# UNITED STATES PATENT AND TRADEMARK OFFICE

APPLICATION NO.	FILING DATE	FIRST NAMED INVENTOR	ATTORNEY DOCKET NO.	CONFIRMATION NO.
10/780,984	02/18/2004	Raymond J. Baxter	11694/04304 (03-002)	3041
27483 7590 06/24/2009 CALFEE, HALTER & GRISWOLD, LLP 800 SUPERIOR AVENUE SUITE 1400 CLEVELAND, OH 44114				
EXAMINER NGUYEN, HUNG D				
ART UNIT 3742		PAPER NUMBER		
NOTIFICATION DATE 06/24/2009		DELIVERY MODE ELECTRONIC

### Office Action Summary

**DETAILED ACTION**

**FIG. 2**

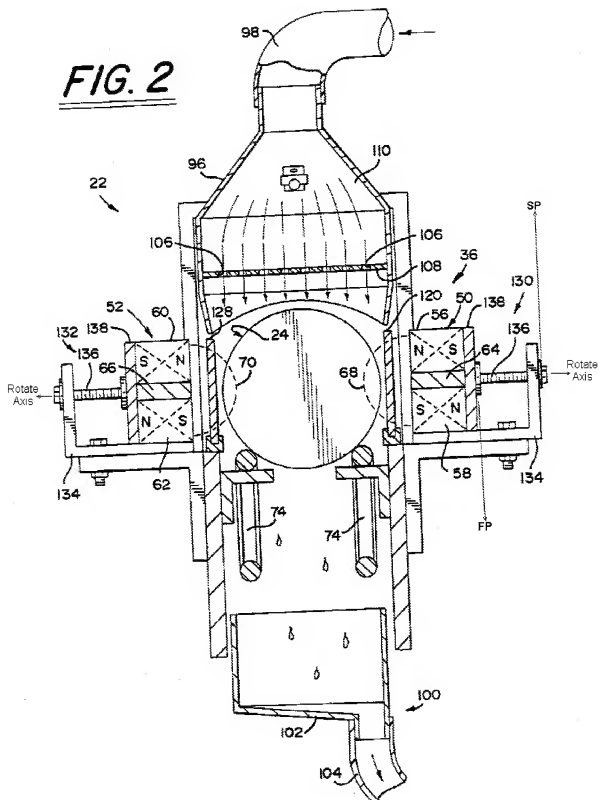
Vejchoda shows the can end curing system with magnetic fanning and belt conveying wherein an adjustment mechanism 130 (Fig. below) comprising a member 136 (Fig. below) that is rotatable about an axis, said rotatable member 136 (Fig. below) having a first portion FP (Fig. below) fixed for vertical movement with said upper guide plate 138 (Fig. below) and a second portion SP (Fig. below) that is threadedly received in a frame portion 134 (Fig. below) of said separator, rotation of said rotatable member 136 (Fig. below) about said axis causing axial movement of said rotatable member 136 (Fig. below) and thereby of said upper guide plate 138 (Fig. below) relative to said frame portion 134 (Fig. below).

It would have been obvious to an ordinary skill in the art at the time of invention to modify Sprenger to use a funnel shape inlet opening of the workpiece passage so that the workpieces are properly aligned to be moved in a predetermined order; and the

adjustment mechanism to control the magnetic fields for further processing to achieve desired results, in view of the teaching of Vejchoda.
